## Firmware 2.06.3 bug list:

## List of bugs/improvement requests

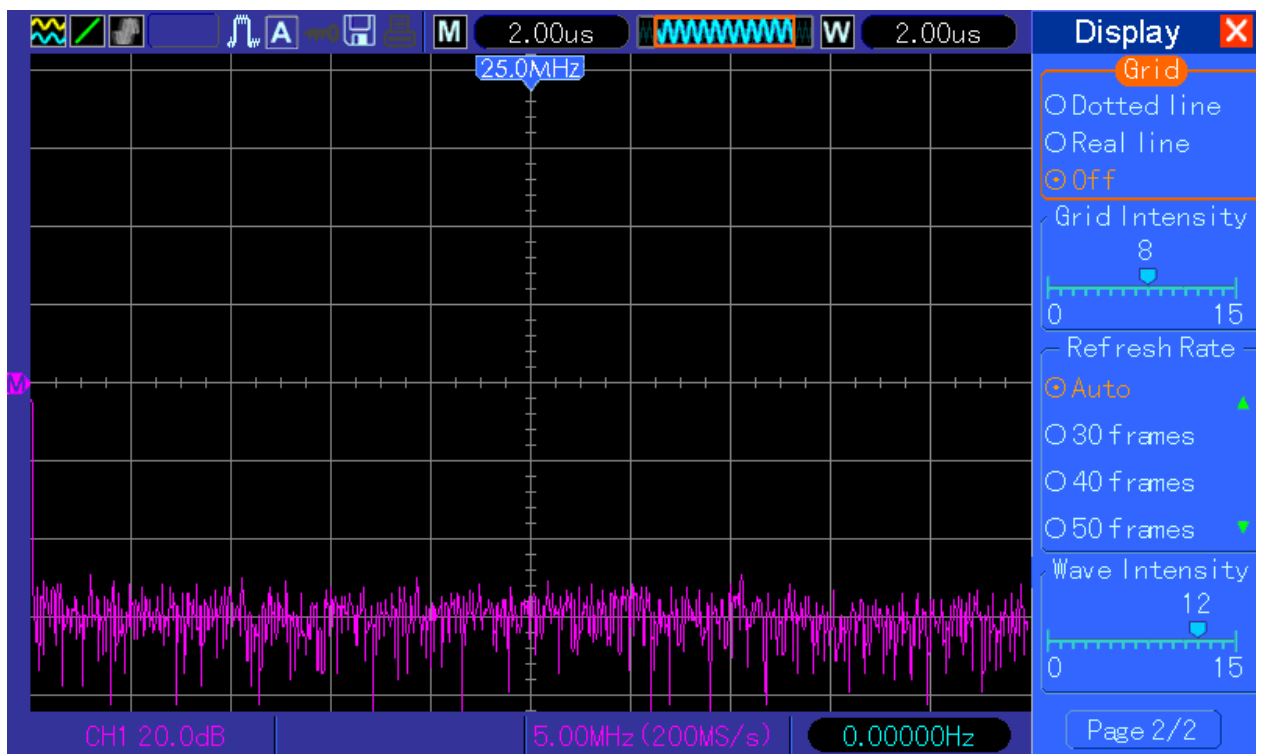
10. In single window mode, sample memory 512k, both channels (ch1, ch2) enabled – when switching to dual window mode artifacts on screen and DSO later crashing and not responding

and switch dual window mode to see artifacts like this:

10. ~~Workaround is to change Timebase (just one step forward and back) right after dual window enabled. Note – the main window (top) need to be activated, the bug have something to do with main TB buffer initialization.~~

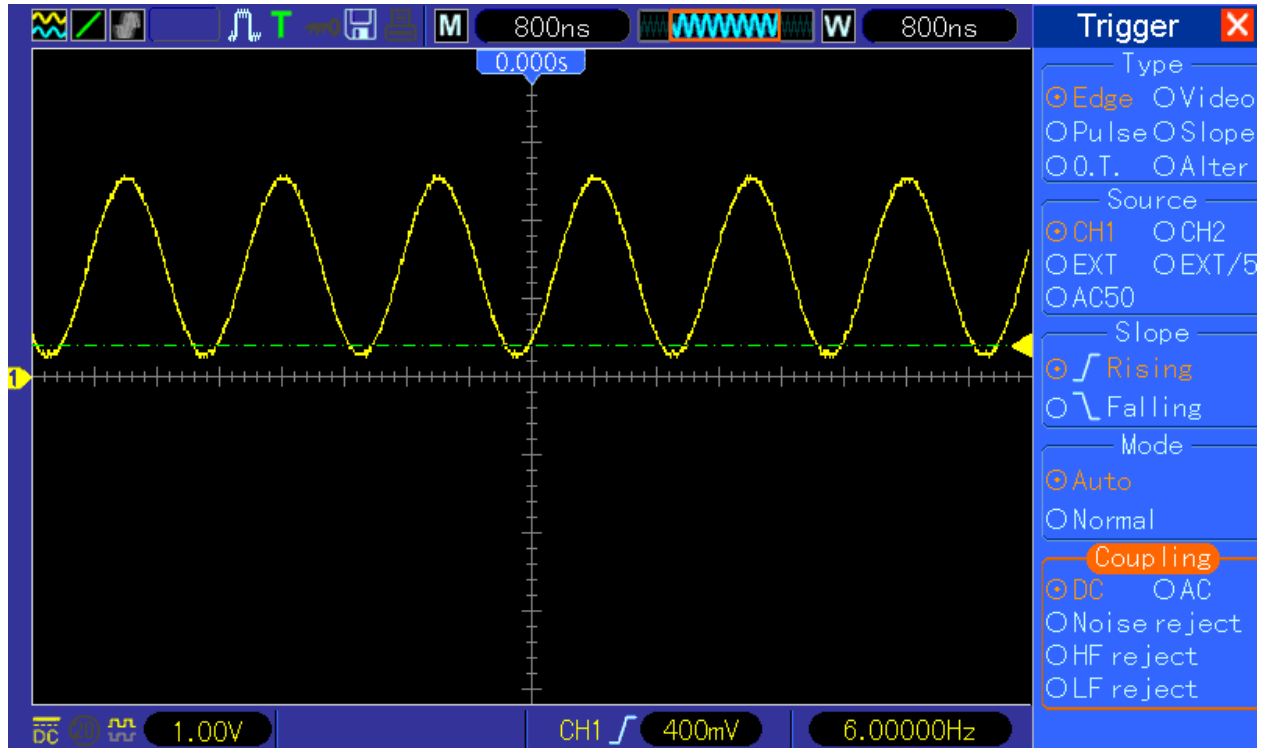
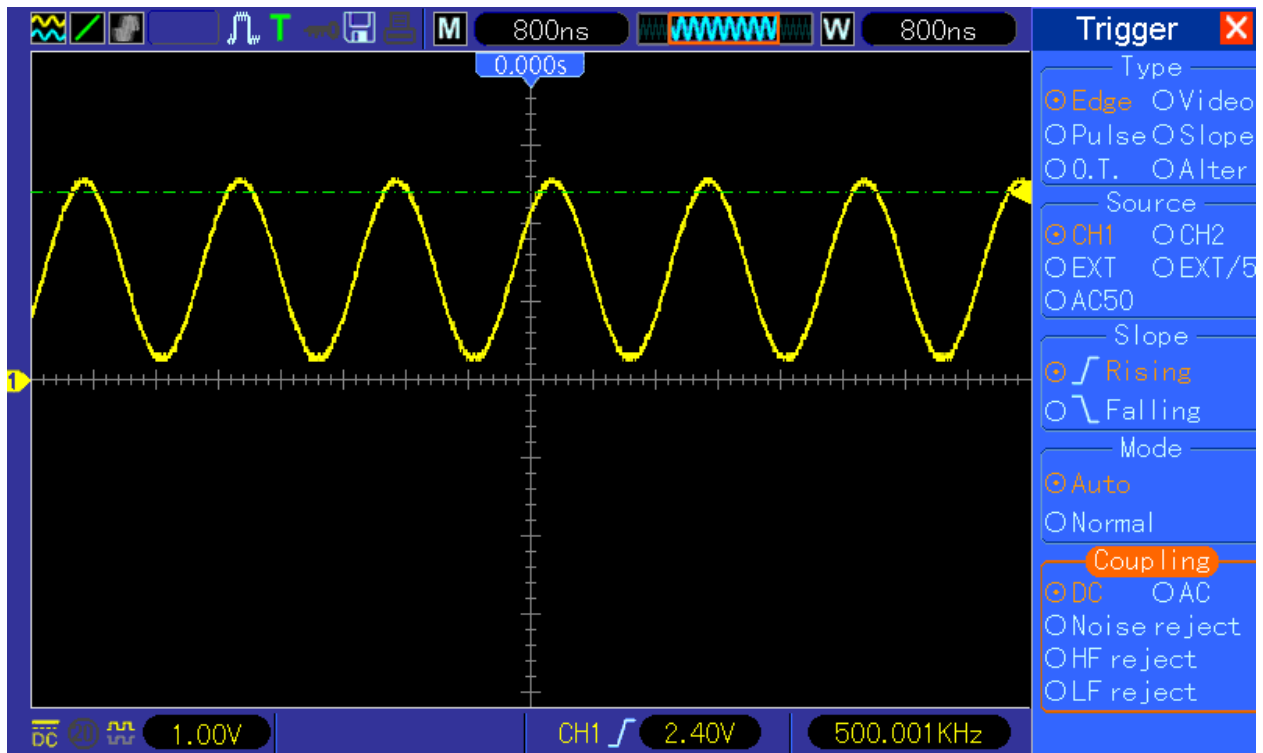
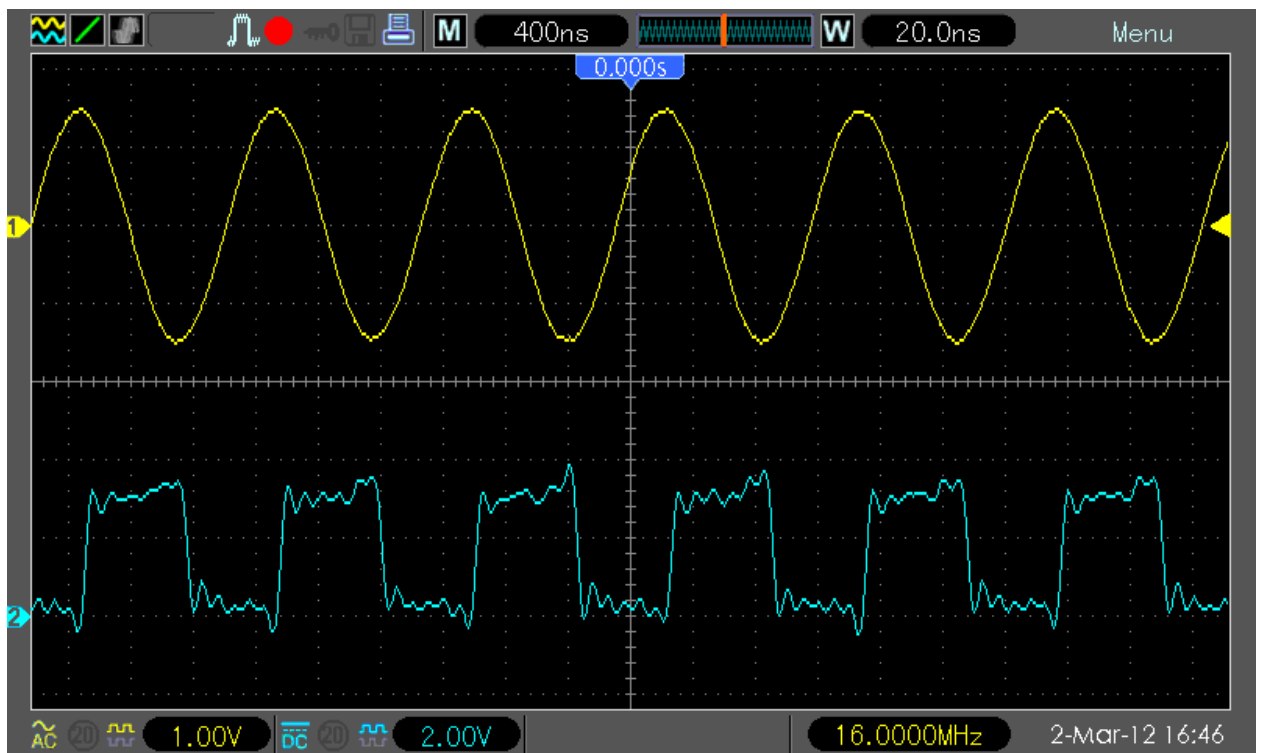
13. AC trigger indicator and line wrong. Set ch1, signal DC coupled, trigger AC coupled. The trigger lowest level below signal :

highest level only mid of signal

But both should look like when trigger coupled in DC mode:

11. ~~This is improvement proposal and not a bug.~~
12. ~~Use my firmware (2.06.3\_120507.6), I removed that bug.~~
13. Use DC trigger coupling or “add offset” when you set trigger point. On some other good known DSOs (e.g. Tektronix TDS7xxx) there is exact the same DC-signal/AC-trigger “dependency” (bug) and nobody ever complained about.

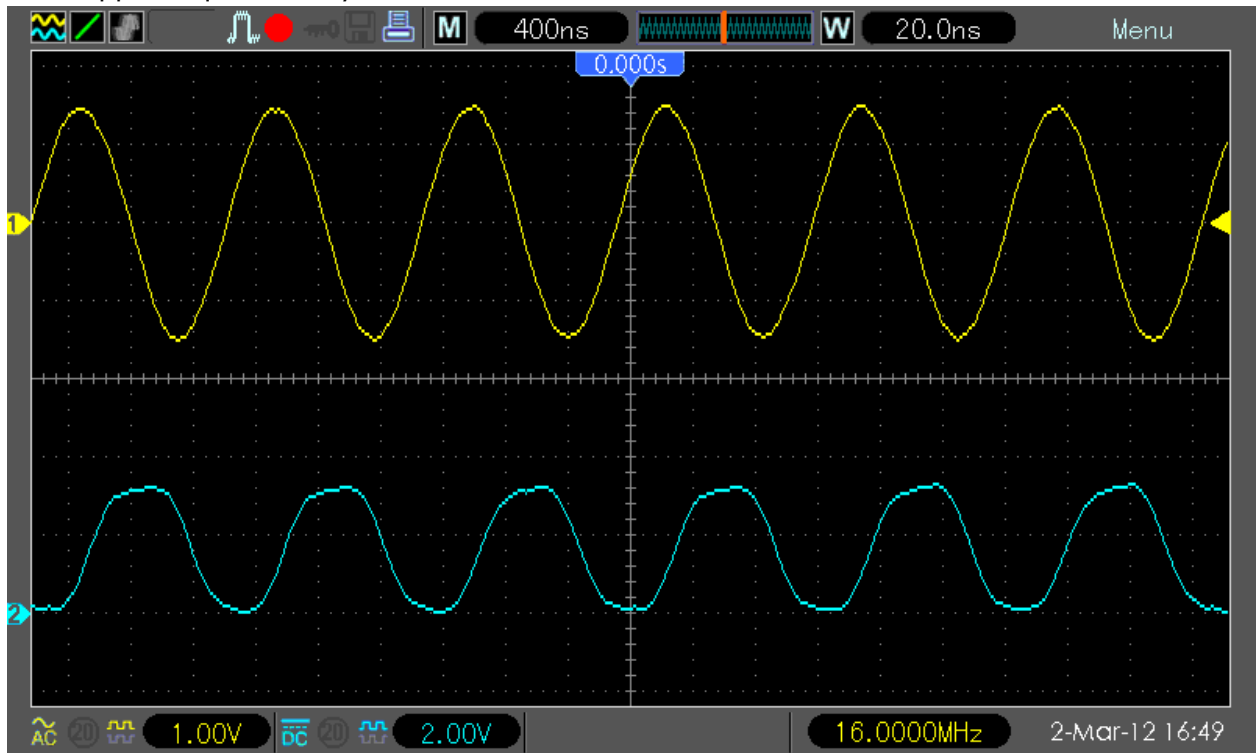
14. Dithering/interpolation filter of waveform too sharp. When enabling both channels (this also occurs in single channel mode and 1GSs, but test signal need to be higher to get same error) and applying for example 16MHz square wave the waveform is switching between proper square:

and crippled square every second:

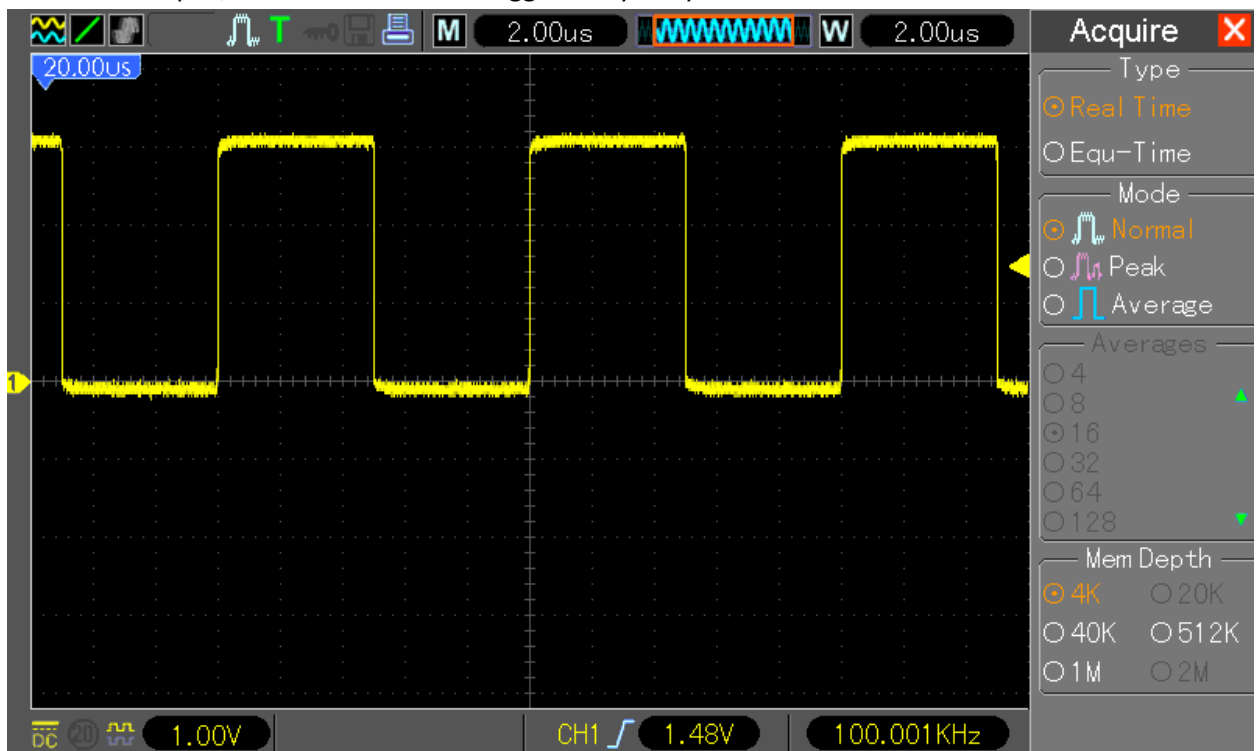
15. Display / Time base scaling strange behavior. When you apply e.g. 1kHz signal, set time base to 80us/DIV and move the waveform to 500us/DIV:

When you now change time base to 40uS/DIV the falling edge (which should be still in the middle of the screen) has been moved to 454uS position (but it should stay on 500uS). The same happens of course with 20uS/DIV.

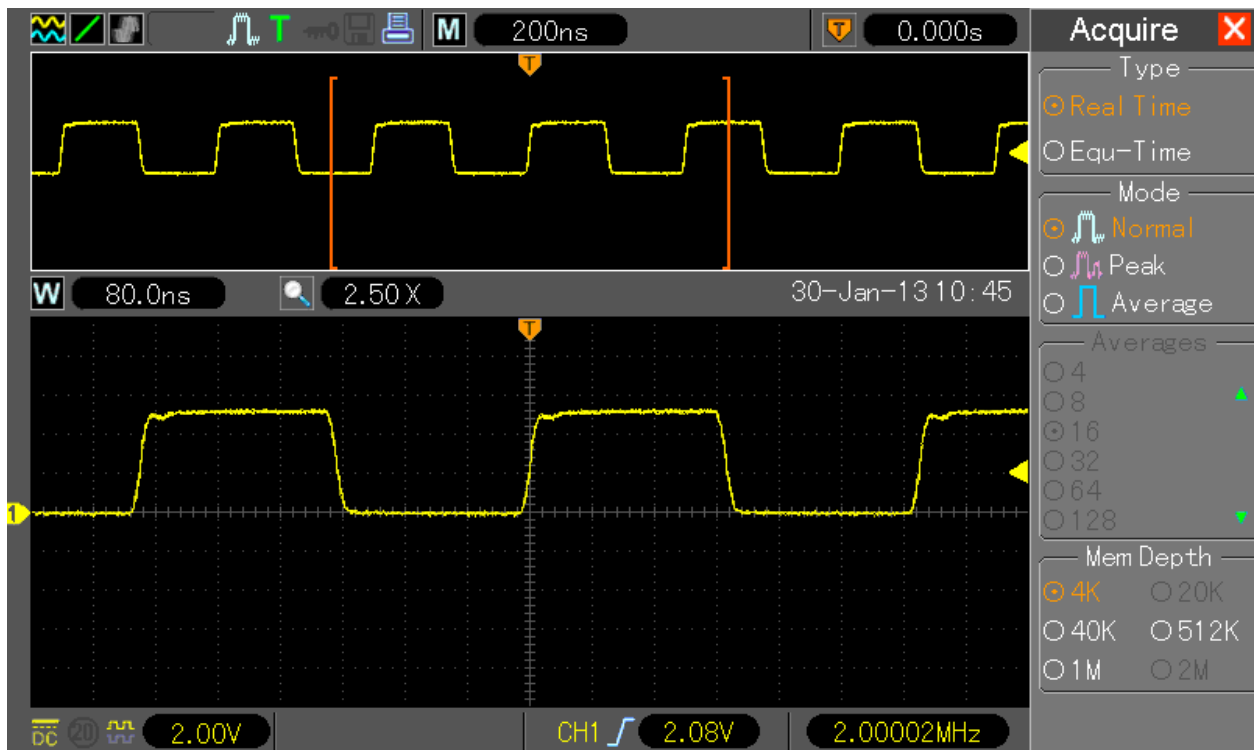
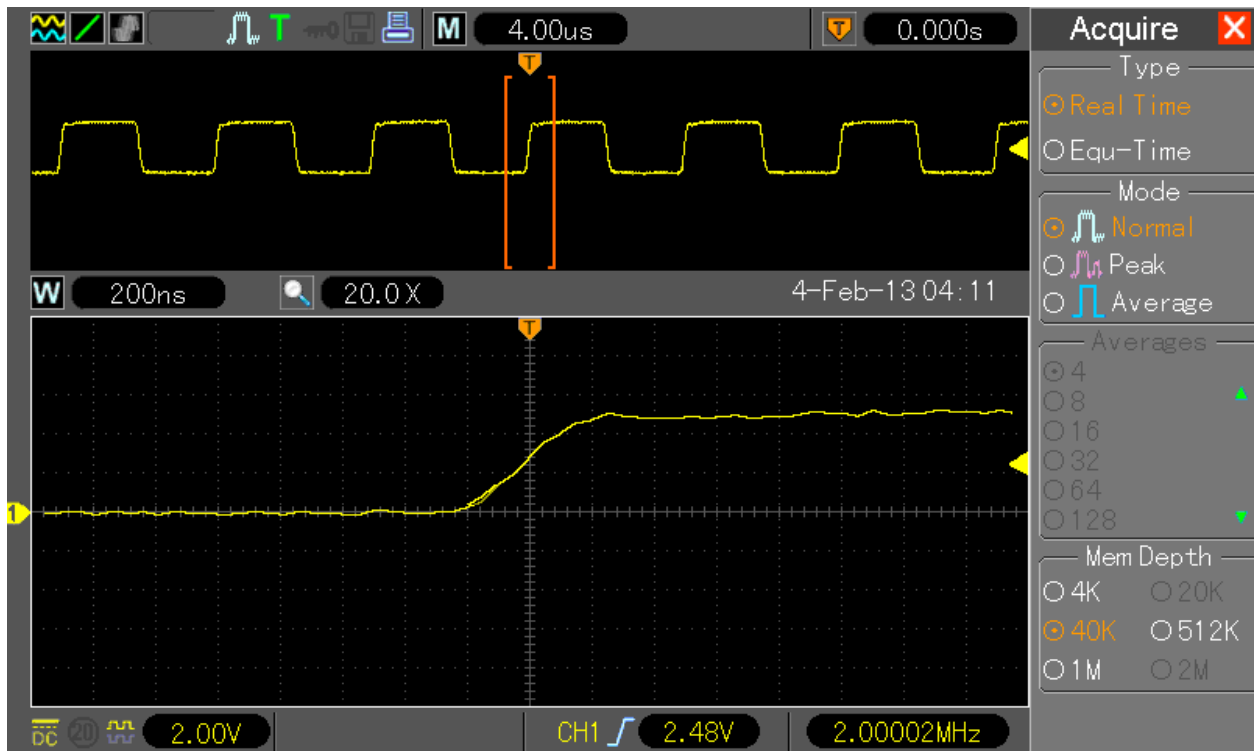
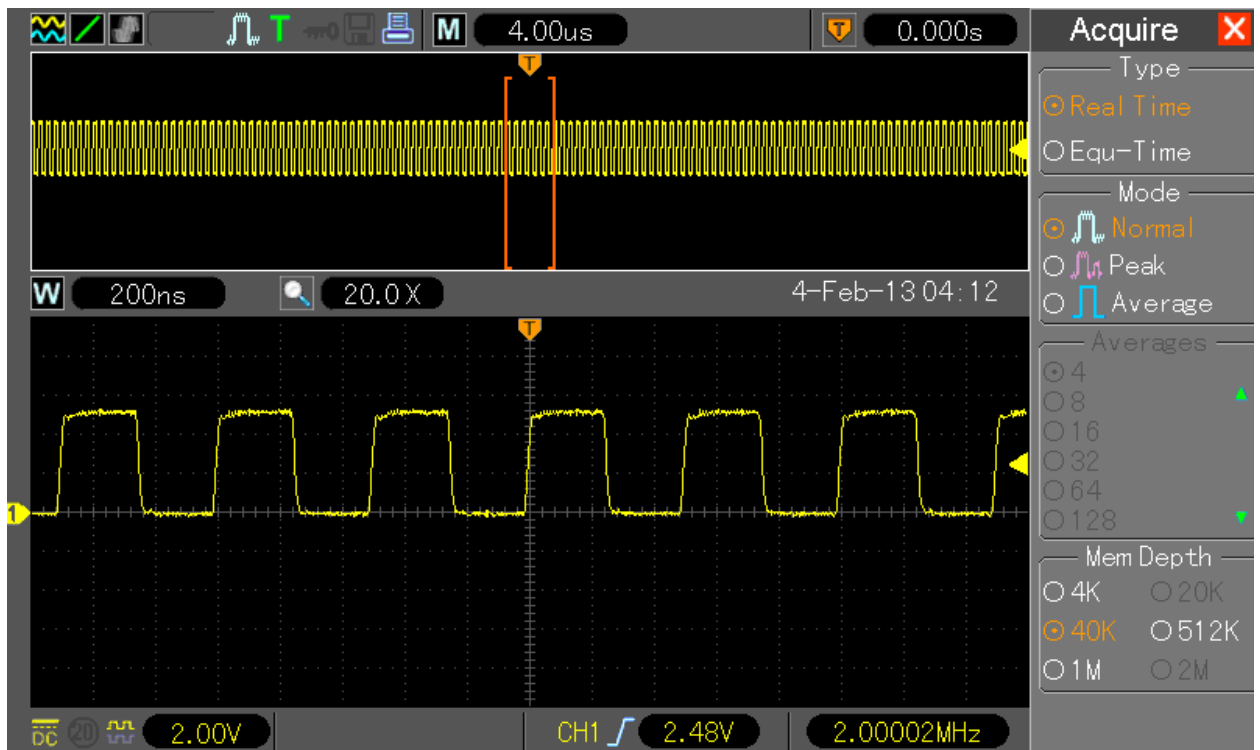
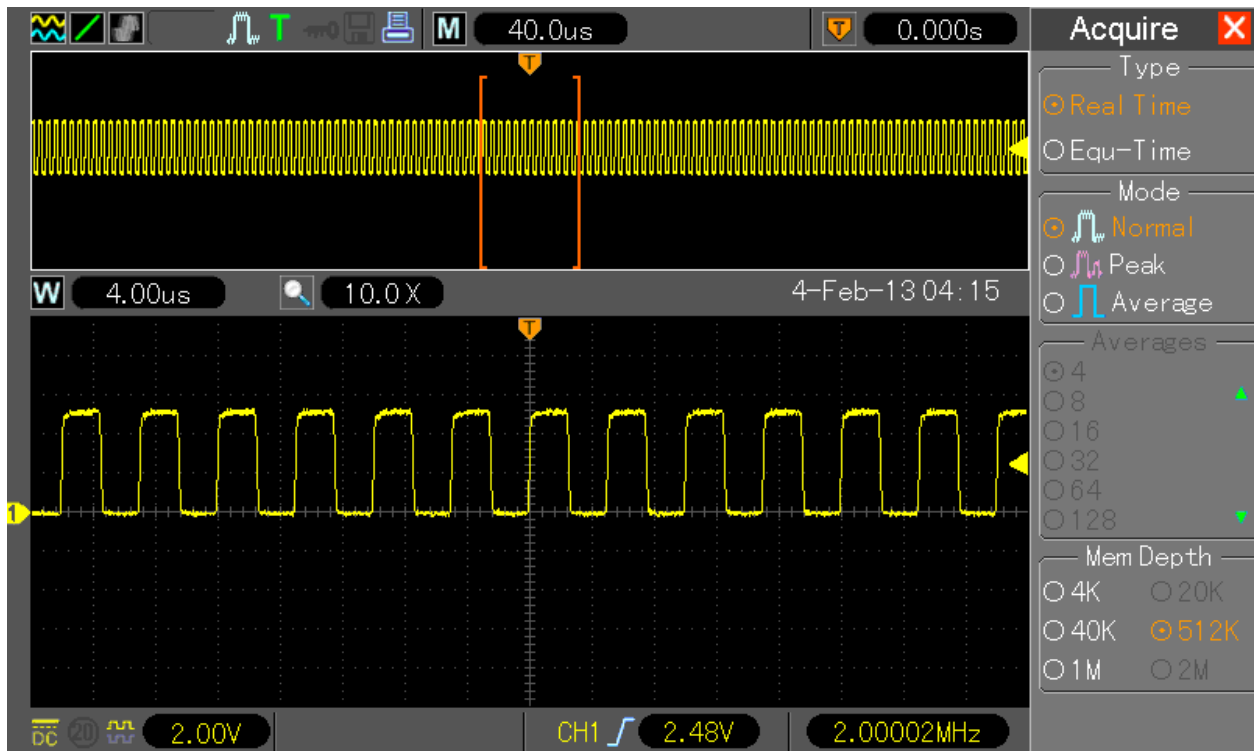
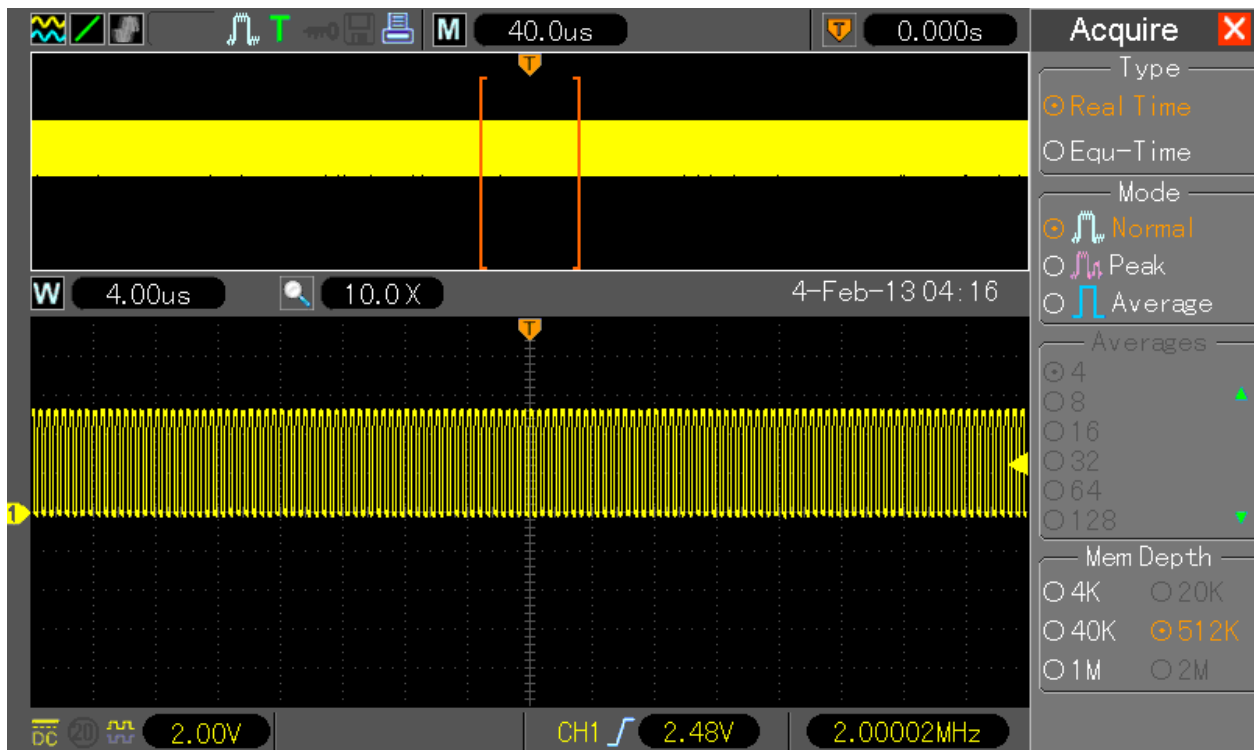
26. ~~While switching to Dual Window (F7), if WTB < MTB, the MTB displayed value is not always set properly. Up to fw 120423.0 it was working properly, in 120808.0 and 121027.0 the MTB scale changed in a completely wrong way (see bug 27), in fw 121208.3 following behavior:~~  
~~This seems to be only issue when MTB < WTB, with MTB=WTB it does works properly.~~

**Update 130202.0 – when switching from single into dual window scaling works. But still there is another one kind of this bug:**

You should see now 2.5 period on screen like here:

Now press F7 to enable dual window. The top MTB window show 6.5 periods and bottom window WTB shows 2.5 periods, which is what it should be:

Now change memory depth to 40k, top window is having still 6.5 periods, this is **wrong**

Switch now focus to top window and turn timebase one position up, the display will be now refreshed to **proper values**:

the same error is there if you change to 512k (and 1M exact same error), push now F5 to change to 512k, picture looks like
